CAMPUS WIDE, REPLACEMENT/REHAB SAN SEWER SYSTEM CAT 5.5
South Dakota State University
Brookings, South Dakota
OSE# R0323--03X/ARPA
2024

ADDENDUM NO. 1

November 6, 2024

SHEET NO.
F003

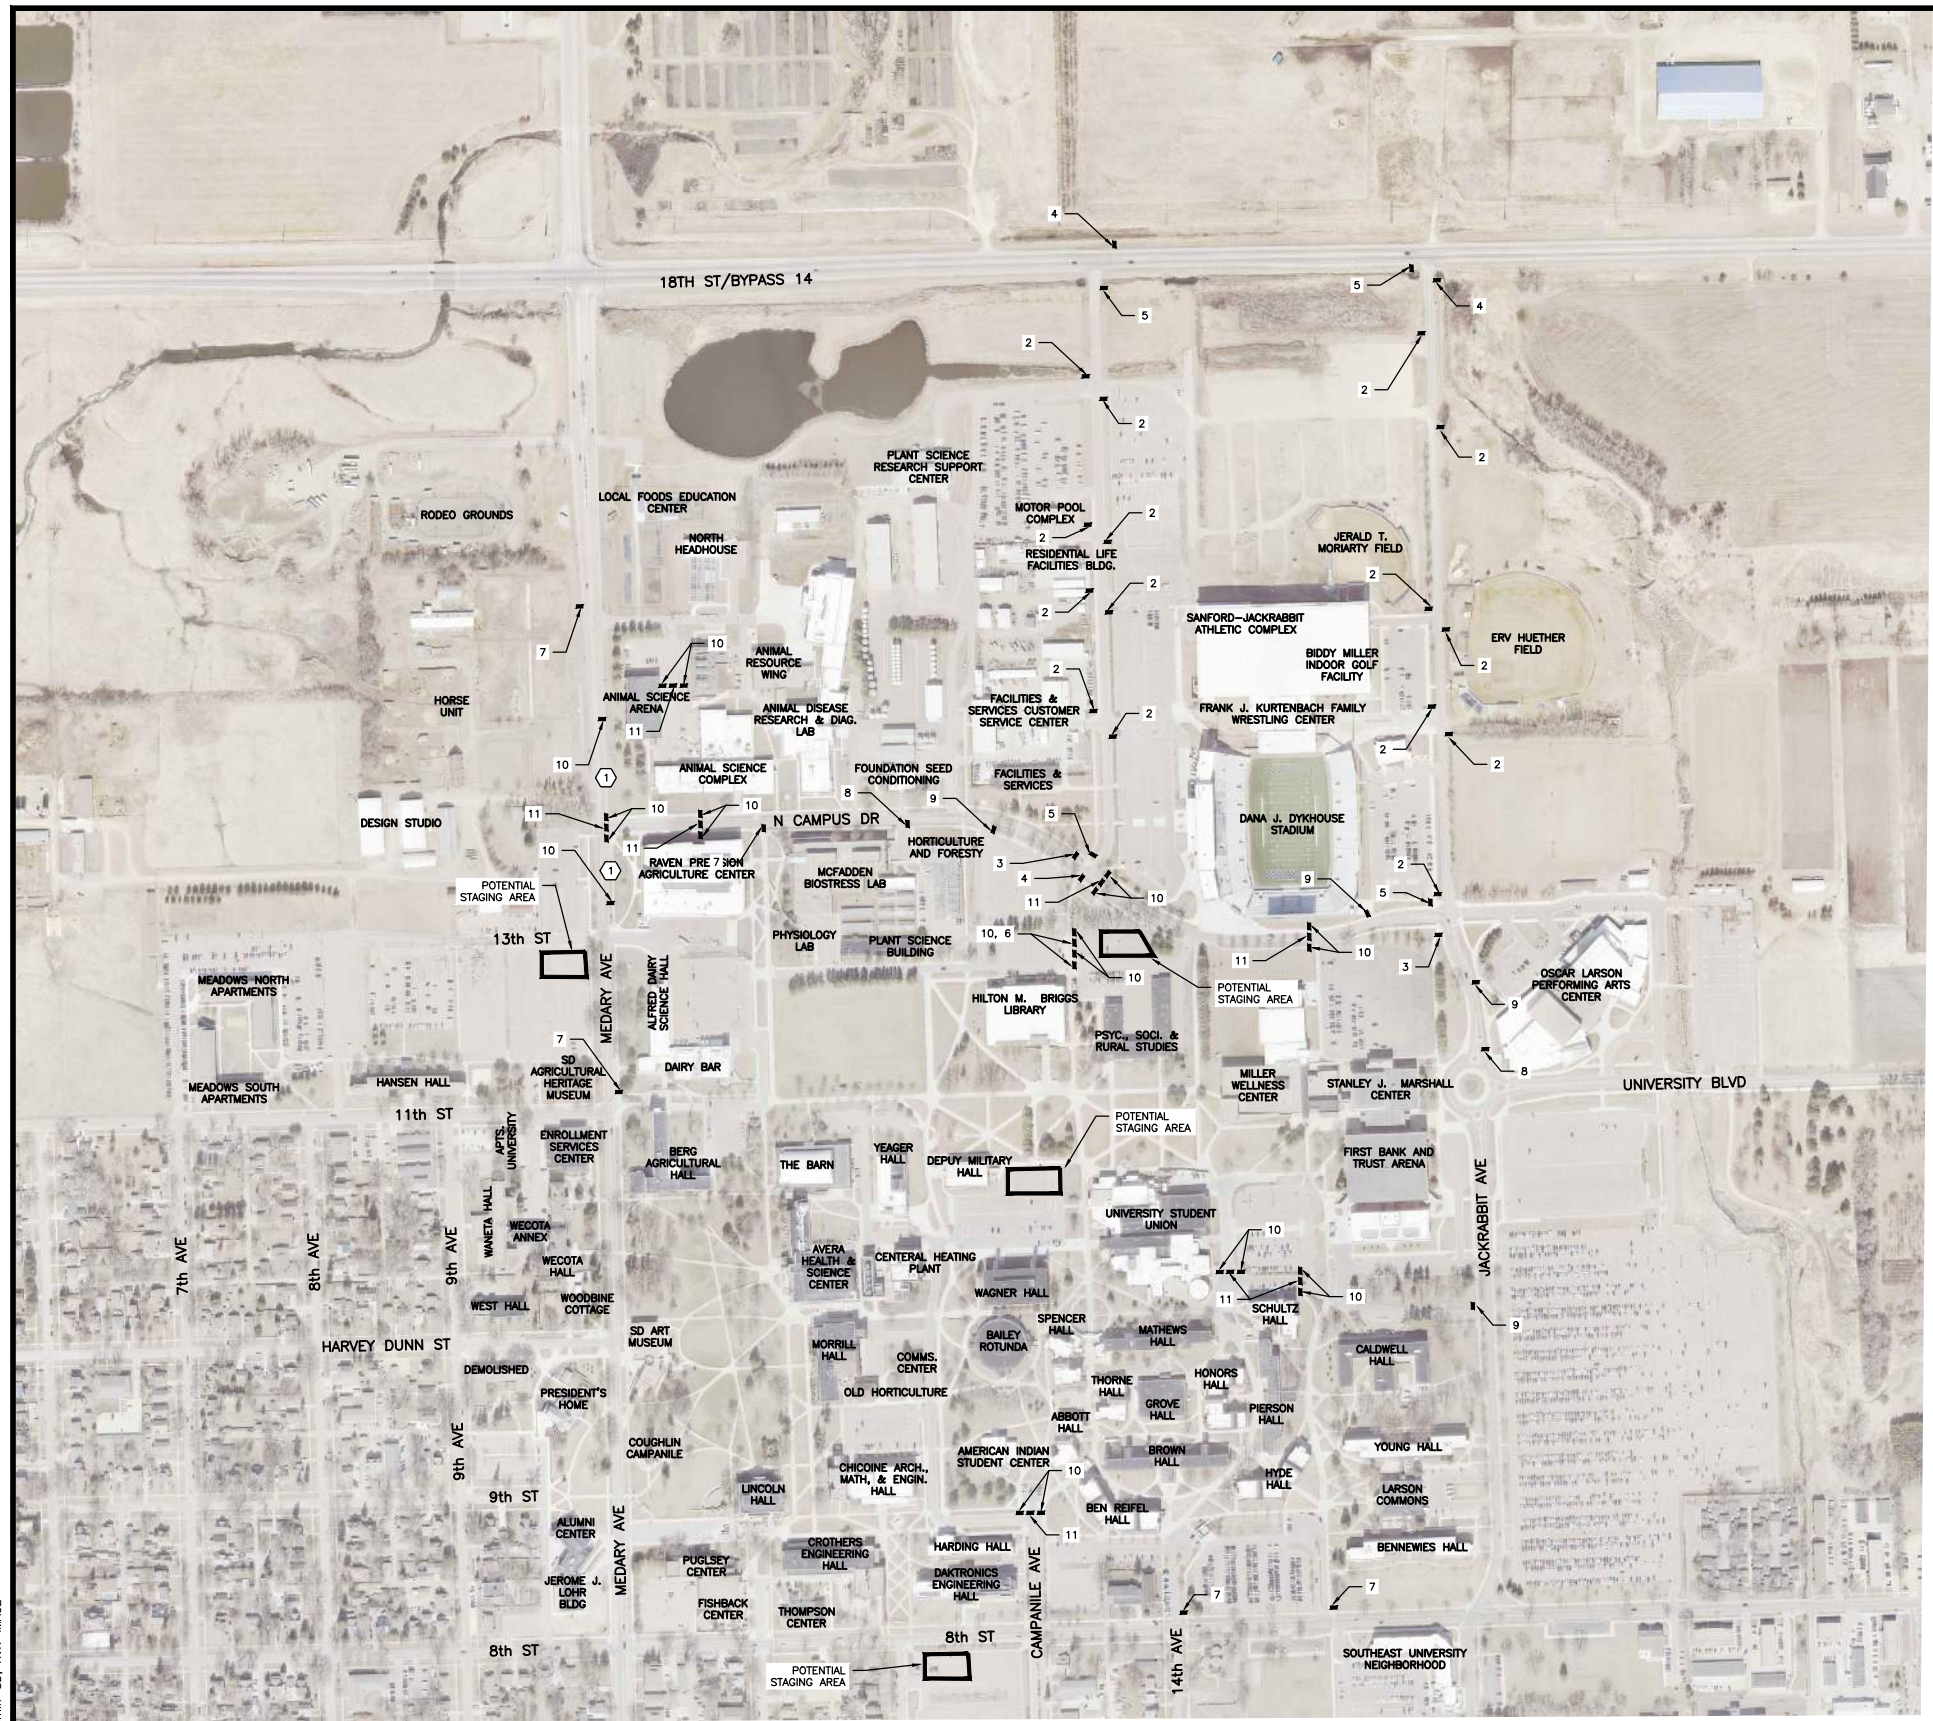
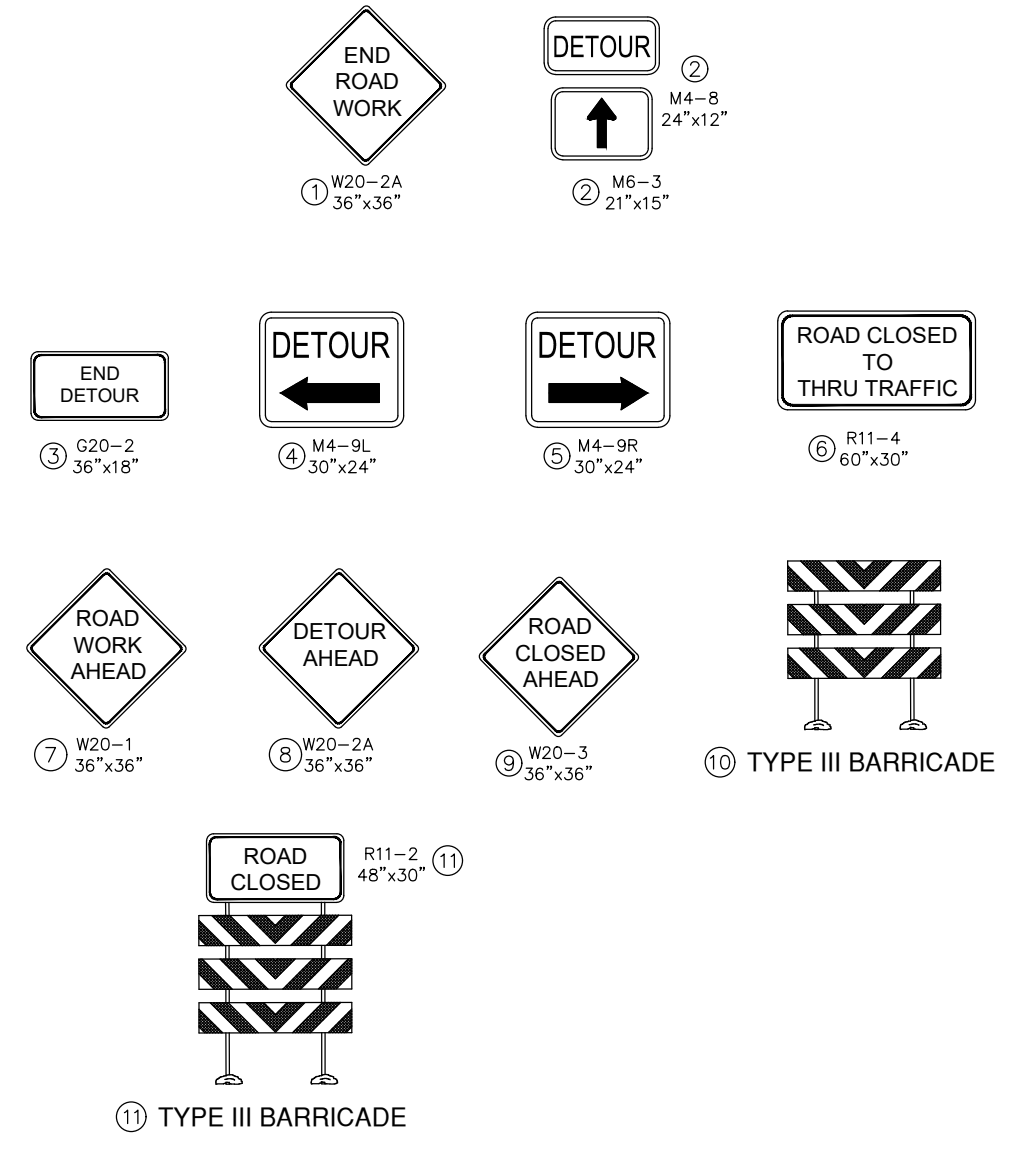
Added traffic control plan detail.

3 TREE PROTECTION DETAIL
SCALE: NTS

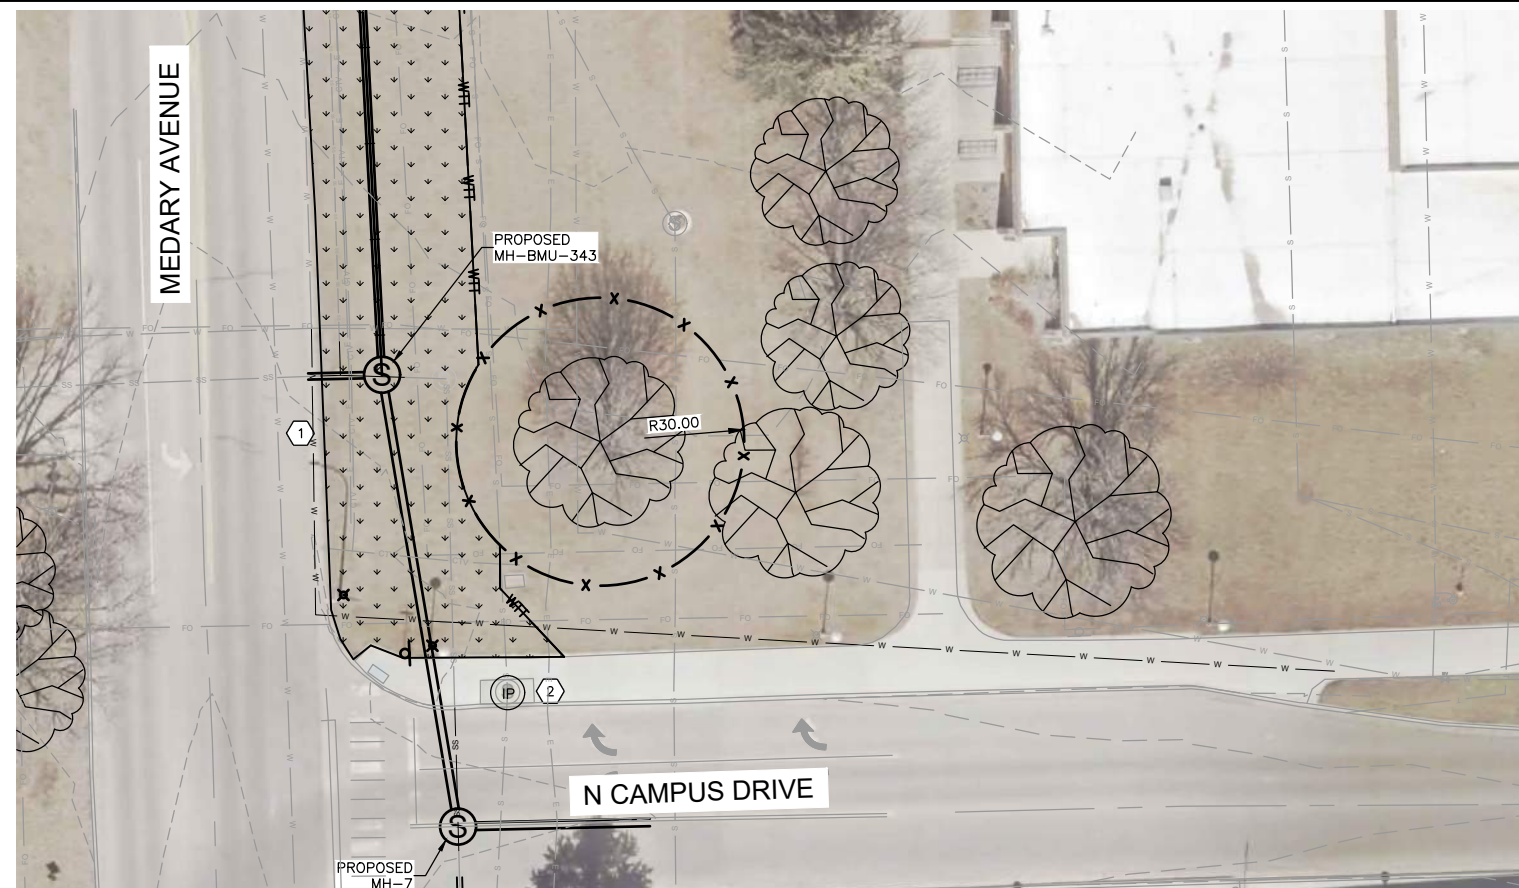
Modified Detail #3, TREE PROTECTION DETAIL.

SHEET NO.
G104

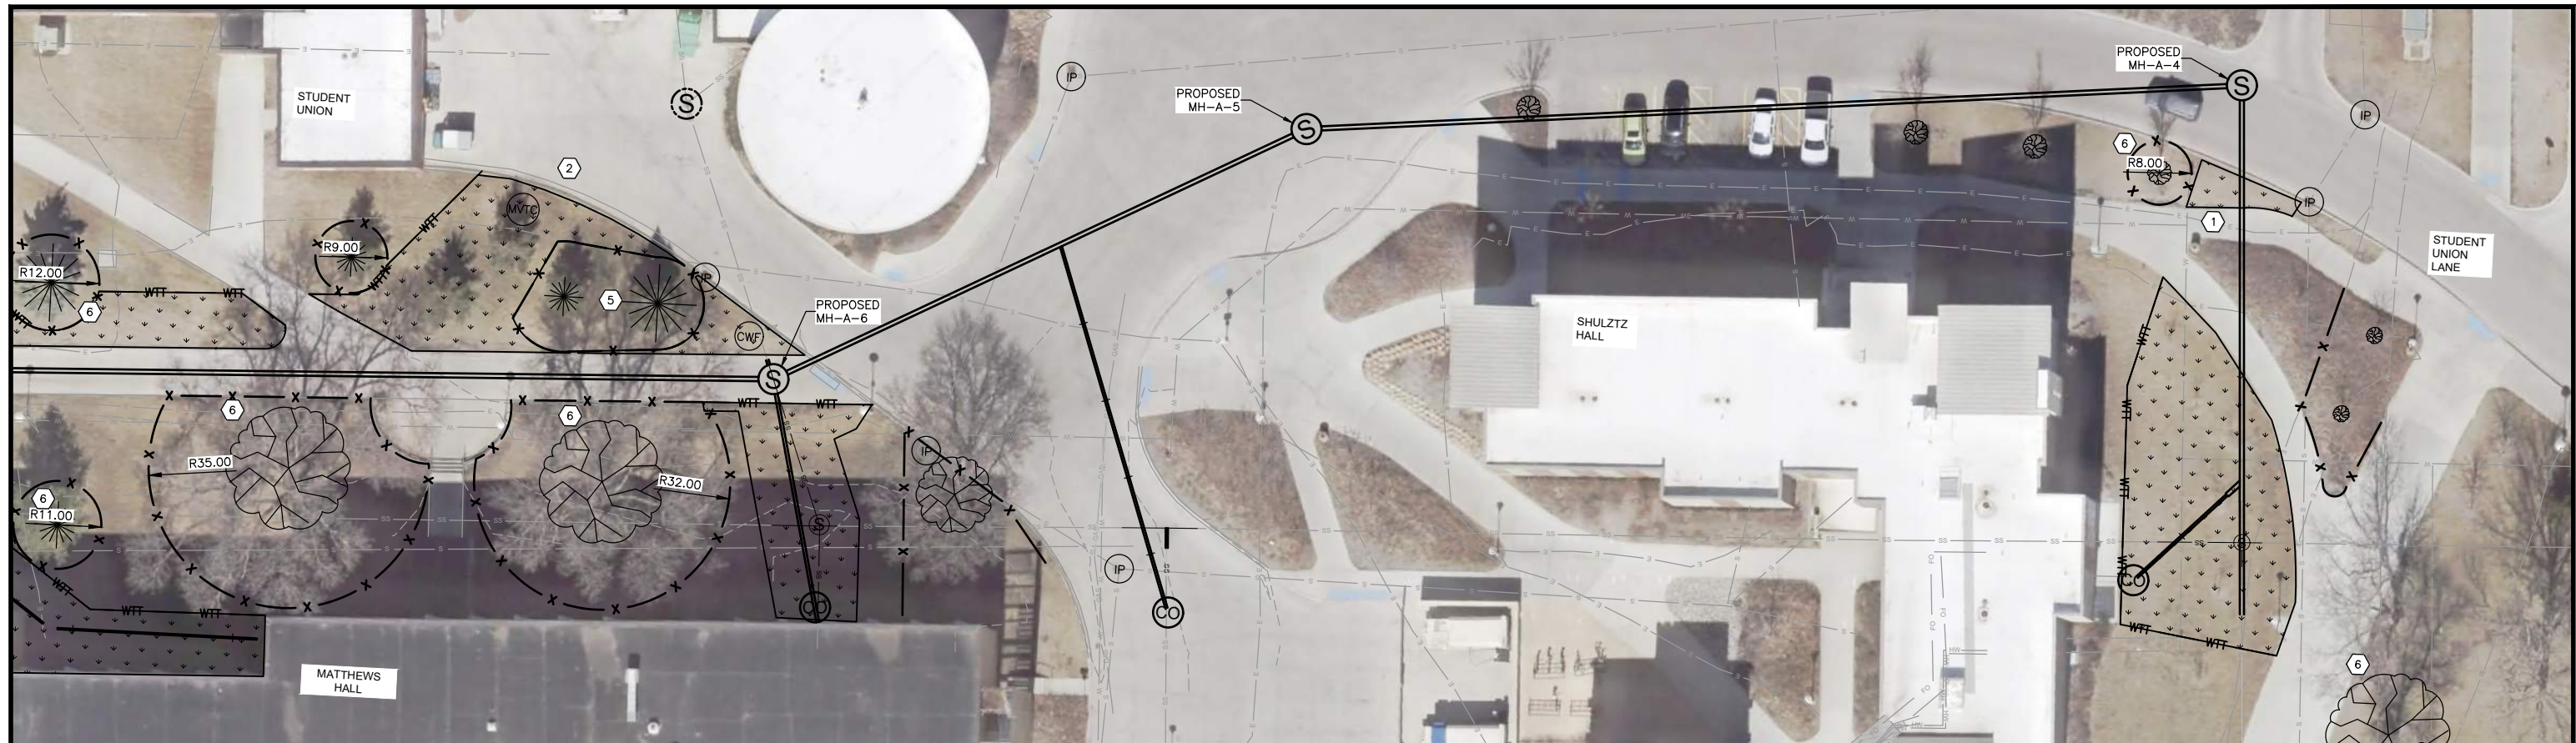
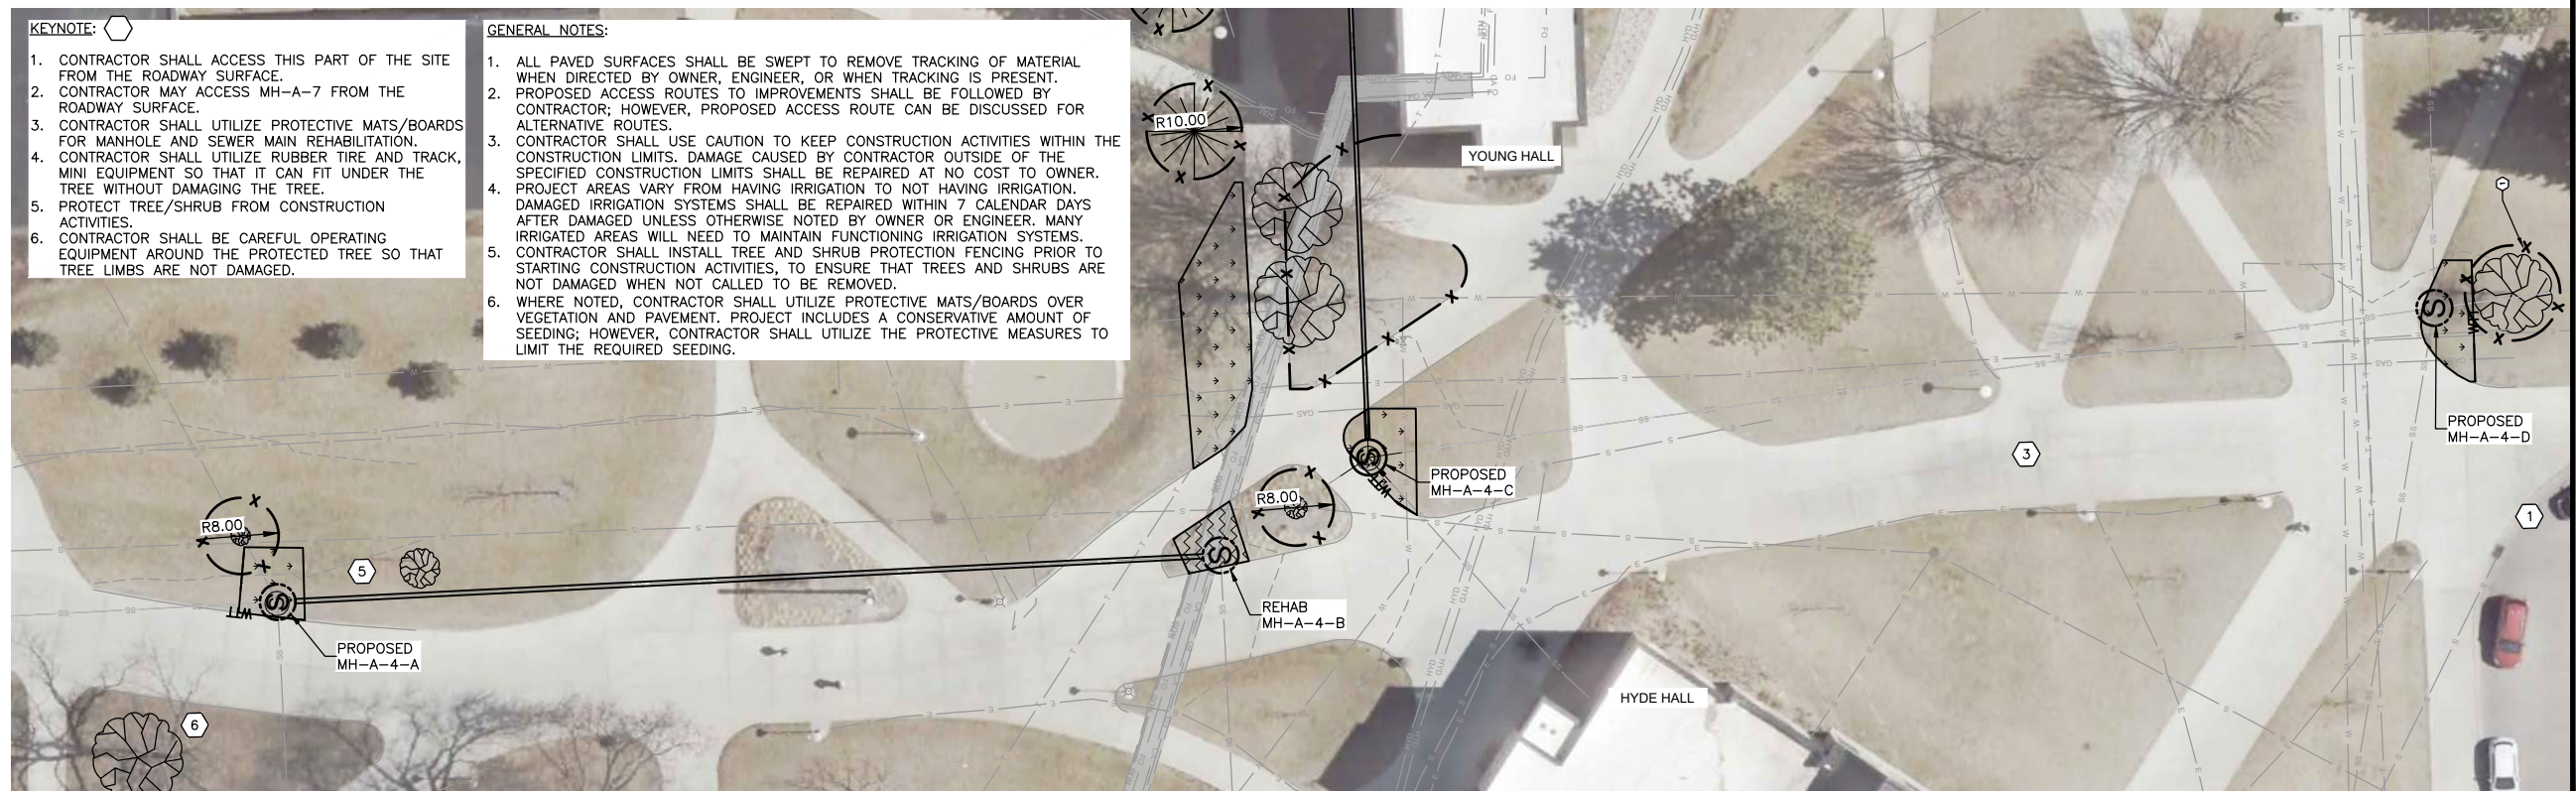
Added tree protection limits.
